California Regional Water Quality Control Board

EL DORADO COUNTY, WDID NO. 6AT50908027

IN THE MATTER OF VIOLATION OF LAHONTAN)
WATER RESOURCES CONTROL BOARD)
RESOLUTION R6T-2007-008, WAIVER OF WASTE)
DISCHARGE REQUIREMENTS FOR DISCHARGES)
RELATED TO TIMBER HARVEST AND) NOTICE OF
VEGETATION MANAGEMENT ACTIVITIES ISSUED) VIOLATION
TO THE US FOREST SERVICE – LTBMU AND)
THE WATER QUALITY CONTROL)

Photo 7: Crossing 11 on Angora Creek still in place on October 13, 2009. Due to increased streamflow and saturated soils, crossing 11 is still in place on October 15, 2009.

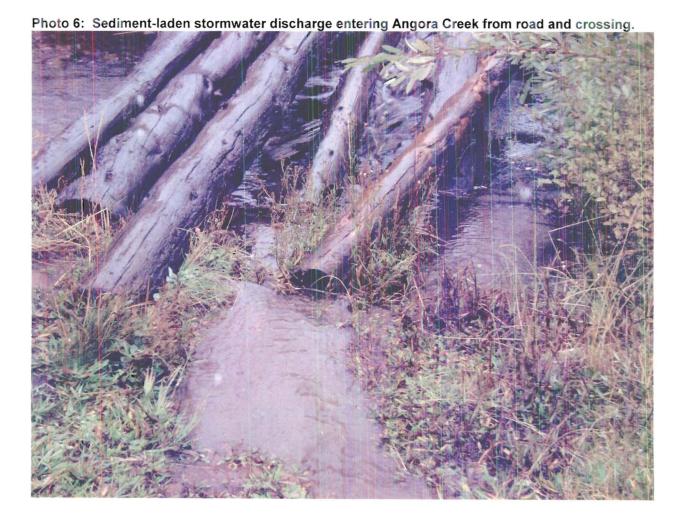
"The crossing will be removed prior to October 15, unless otherwise agreed upon between the LTBMU and Lahontan staff."

Refer to Photo 7, taken on October 15, 2009, showing the crossing 11 on Angora Creek in place. An email received on October 13, 2009 from LTBMU staff states that "Crossing 11 is still in as there are still logs in the Seneca Pond landing that still need to be chipped."

- 1. <u>Immediately</u> cease any and all new soil disturbance activities. You are only authorized to **stabilize** areas already disturbed by Project activities.
- 2. To completely stabilize all disturbed soils on Project sites by October 23, 2009, including decommissioning roads, trails, and removing temporary crossings as described in the Decision Memo and project documents which may amend the Decision Memo.
- 3. Decommission the former primary access road at the Seneca Drive entrance to Unit 5 by October 23, 2009.
- 4. Submit a report to the Lahontan Water Board by <u>October 30, 2009</u>, which describes and documents the completion of site stabilization activities per identified project area. Documentation must include photo documentation.
